VILLAGE OF LOMBARD
INTER-DEPARTMENTAL REVIEW GROUP REPORT
ADDENDUM REPORT

MEETING DATE: August 3, 2022

SUBJECT: **PC 22-20: 4-44 Yorktown Center YTC Parcel 4 – D. R. Horton Townhomes**

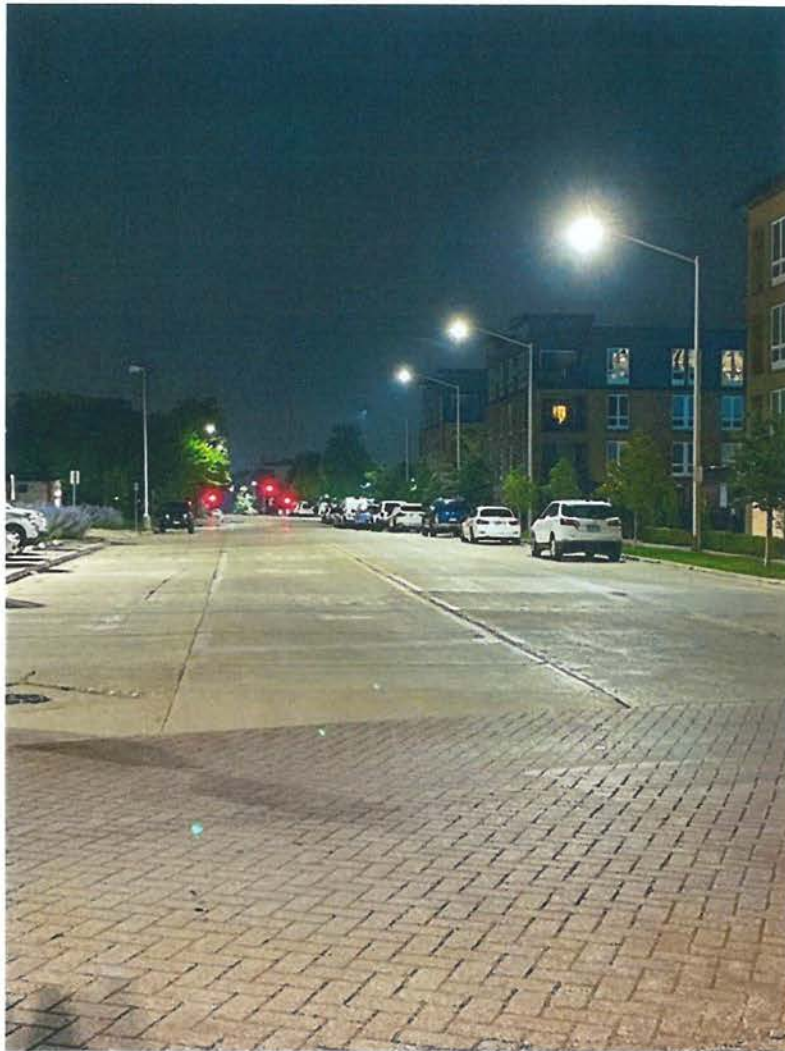
Along Grace Street, a publicly dedicated right-of-way maintained by the Village of Lombard, the street has been improved with cobra streetlights, which are situated on the west side of Grace Street north of the subject property and on the east side of the street adjacent to the subject property and next to the Elan apartment building.

Section 600.02 of the Village's Specifications Manual requires that local residential streets be illuminated to a minimum maintained level of 0.2 foot candles. As shown on the submitted photometric plan, the lighting along Grace Street meets the 0.2 foot candle requirement. The below photo, taken after nightfall on Grace Street, shows the illumination level along Grace Street.

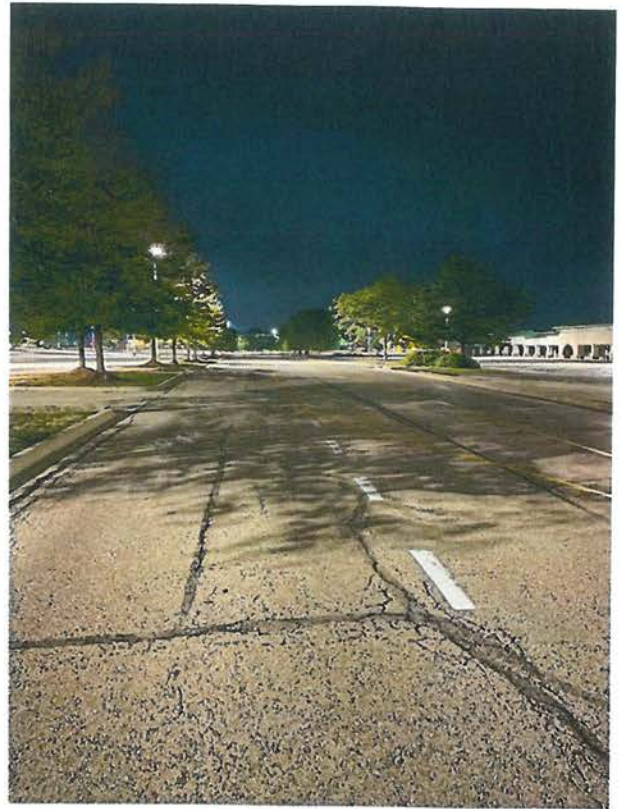
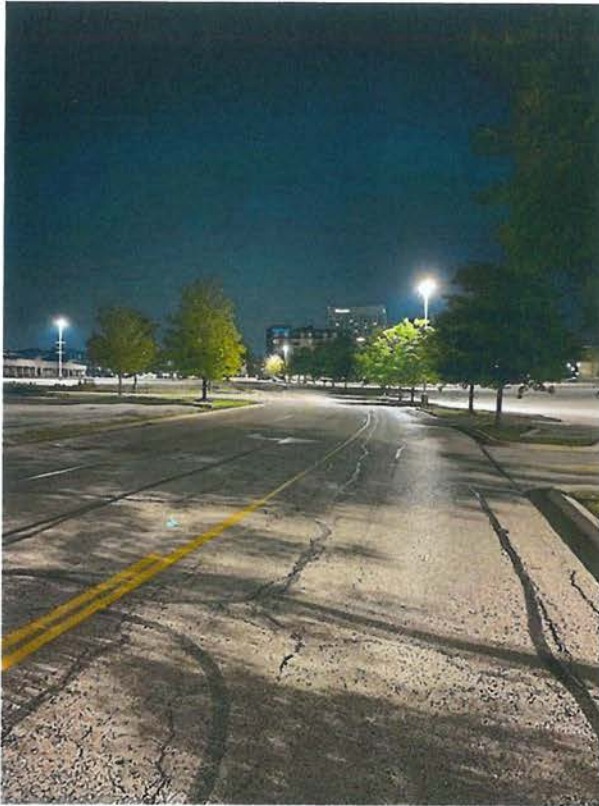
Yorktown Center Ring Road, a private access driveway maintained by Yorktown as common area element. As an extension of the overall adjacent parking lots, the road is illuminated in a manner required by Village Code and consistent with the adjacent parking lots.

Abutting the parking fields, the road is primarily illuminated by two light poles with two light fixtures on each pole. The western light pole is located close to the proposed residential subdivision entrance, while the eastern pole is situated closer to Grace Street. These two light poles, as well as other ambient lighting in the parking lot, cast light into both the parking lot and the road itself. A walk along the road along the curb lines found light meter reading between 0.2 and above 2.0 foot candles (fc) near the light poles, depending on location.

4. Along the ring road and recognizing that single-family residents may be more concerned about excessive light spill from the mall parking lot, additional lighting is not necessary.
